RE: St. Lucie Unit 2  
Docket No. 50-389  
Proposed License Amendment  
Add COLR Methodology - Improved Heat Flux Correlation

ATTACHMENT 3

St. Lucie Unit 2 Marked-up Technical Specification Pages

FIGURE B 2.1-1  
Axial Power Distributions For Thermal Margin Safety Limits

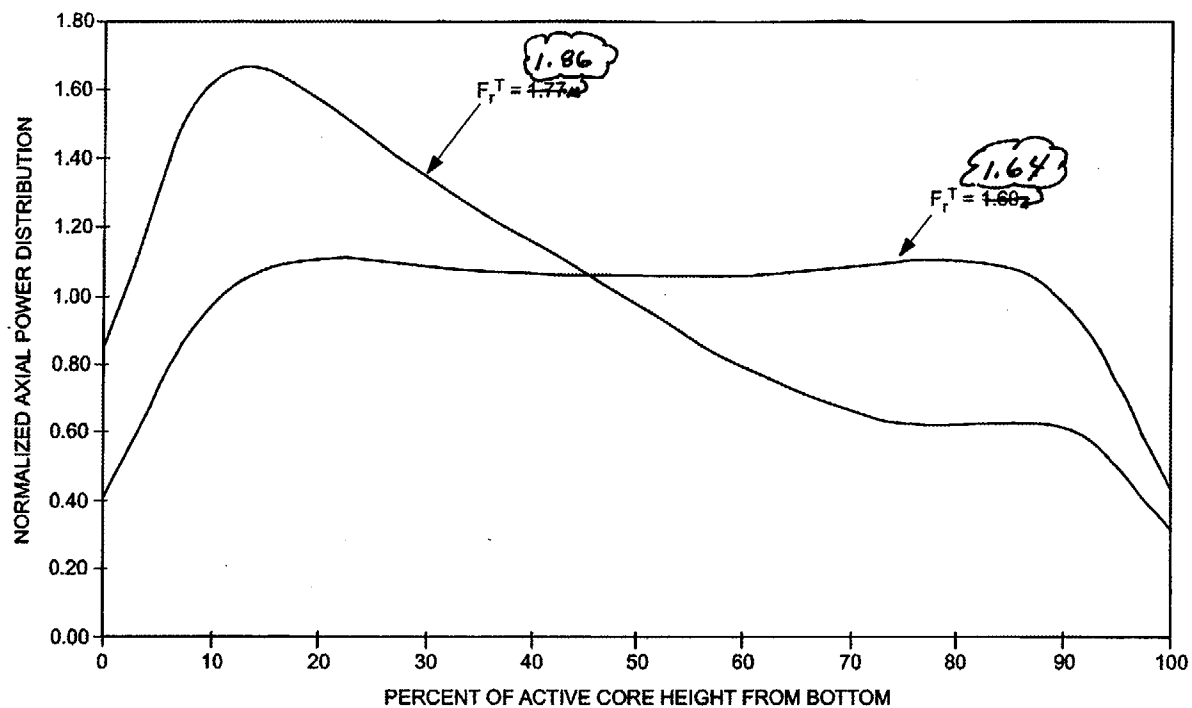
The Bases for TS 2.1.1 are clarified with respect to the application of ABB-NV DNB correlation and the Bases Figure B2.1-1, supporting the curves of thermal margin safety limit lines Figure 2.1-1, is revised to reflect the application of ABB-NV critical heat flux correlation.

The text in the Bases for TS 2.1.1 is modified to reflect the application of ABB-NV DNB correlation. Accordingly, references to CE-1 critical heat flux (CHF) correlation are modified to quote both CE-1 and ABB-NV correlation. Also, the TS Bases Figure 2.1-1 is modified to reflect the implementation of ABB-NV CHF correlation. The use of appropriate NRC approved DNB correlation is stipulated by TS 6.9.1.11. Specific analysis will use the appropriate DNB correlation and the corresponding DNBR limit to ensure that the thermal margin DNBR limit is not violated for the combination of transient conditions initiated within the limiting conditions of operation in combination with the reactor protection systems.

*yes based on ABB-NV CHF correlation*
